1391 KENTRICK AVENUE
TALAMA PARK

Staff Item #2—Anne Fothergill
September 9, 2009
7391 Buffalo Avenue, Takoma Park
Non-Contributing Resource

The HPC approved alterations at the rear of this house including a ground level screened porch and a deck off the first floor. The applicants are now requesting minor changes and staff is requesting that the HPC allow these changes to be approved at the staff level.

PROPOSAL: Deck expansion and stairs, screened porch construction, and basement window installation

SITE PLAN

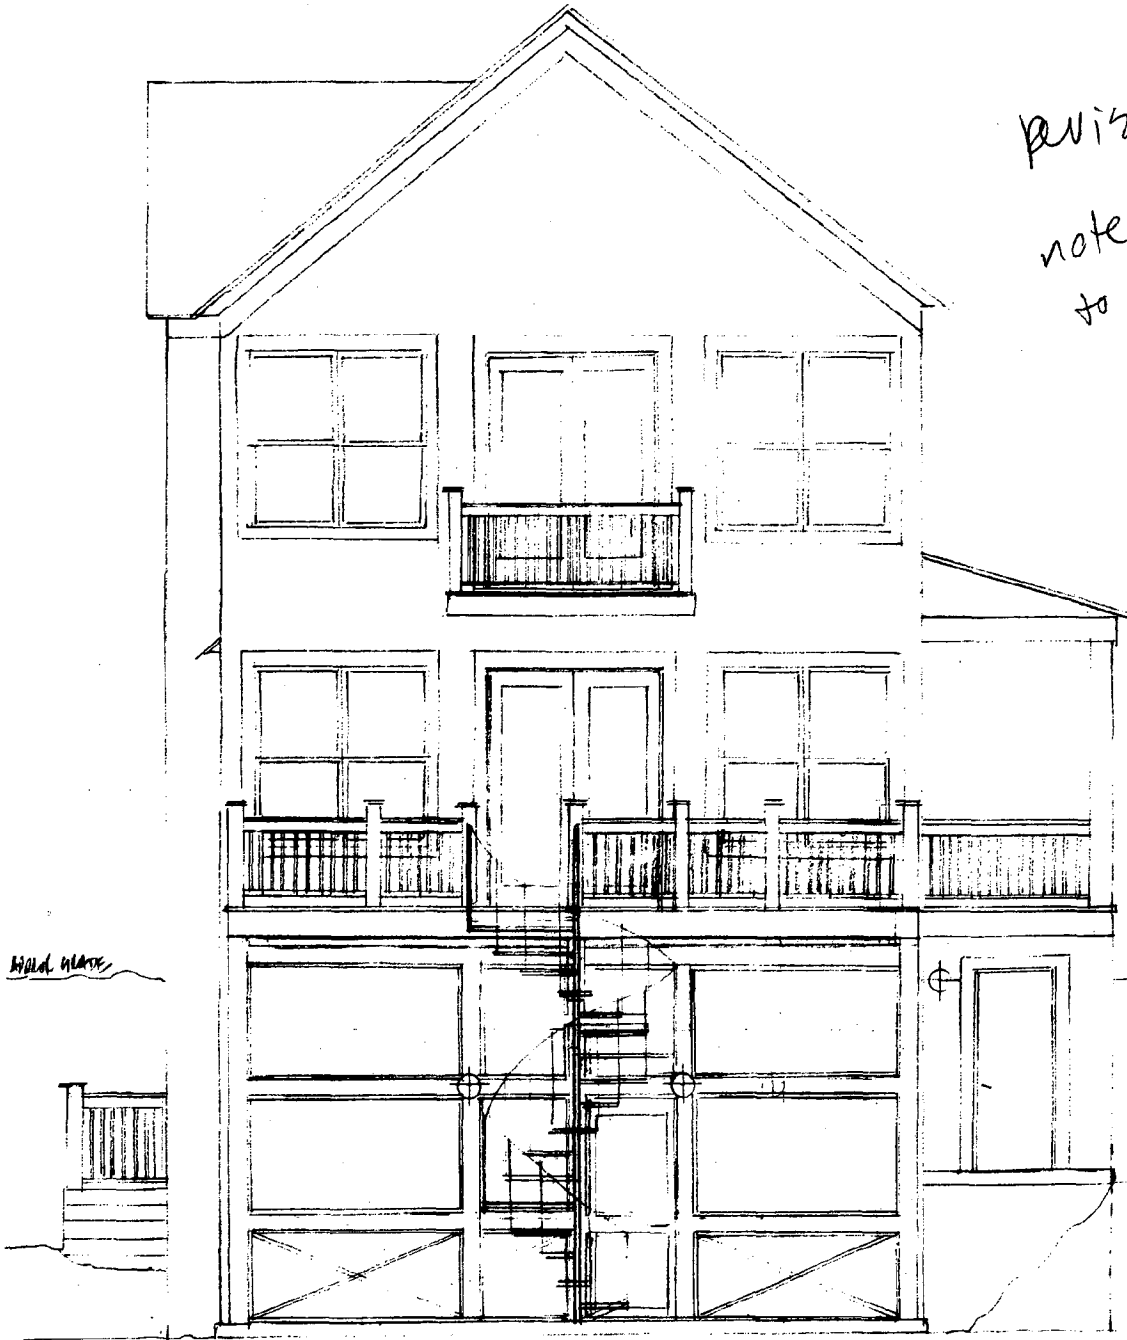
3'0" New Window

6'0" New Glass

22'0" New Second Floor
 Balcony enlarged Deck
 (original deck ~ 16'0")

4'6" New Door

DATE: _____
PLAN: REAR ELEV
FLOOR: _____
SCALE: 1/4" = 1'0"

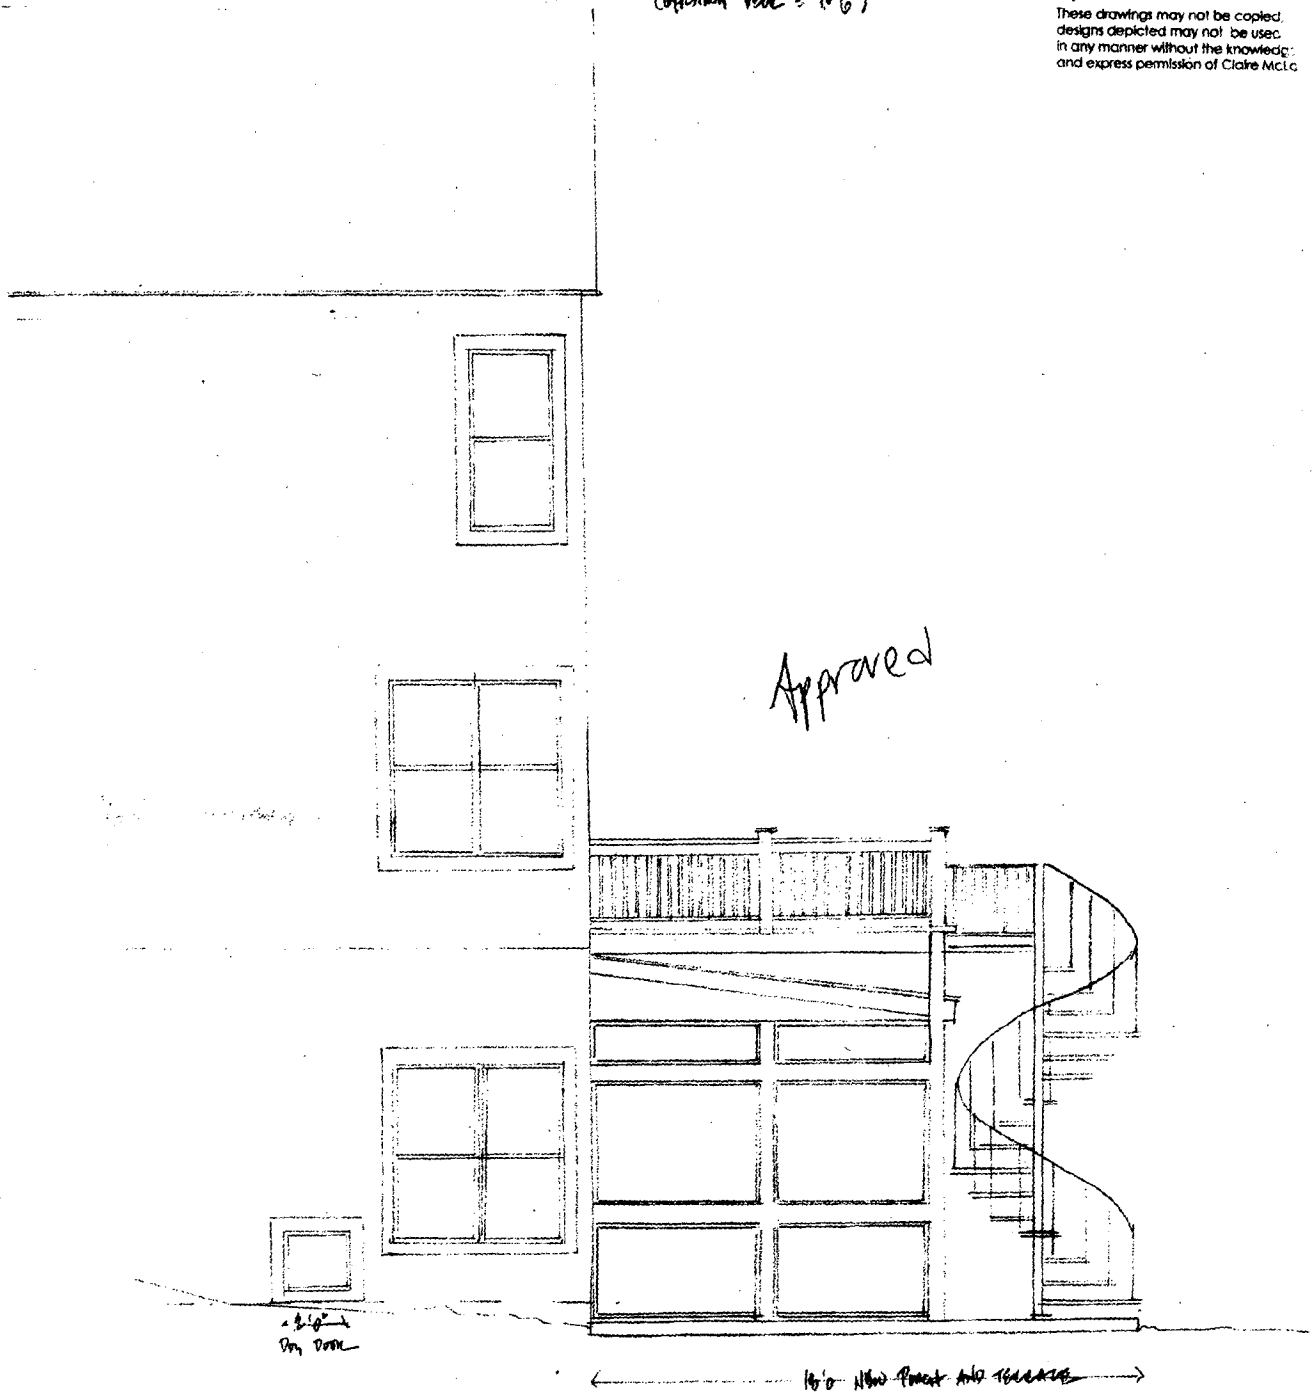
revised
note door
to screened
porch

< 6'0" new stairs >

24'0" New screened porch
with enlarged deck
(original deck ~ 16'0")
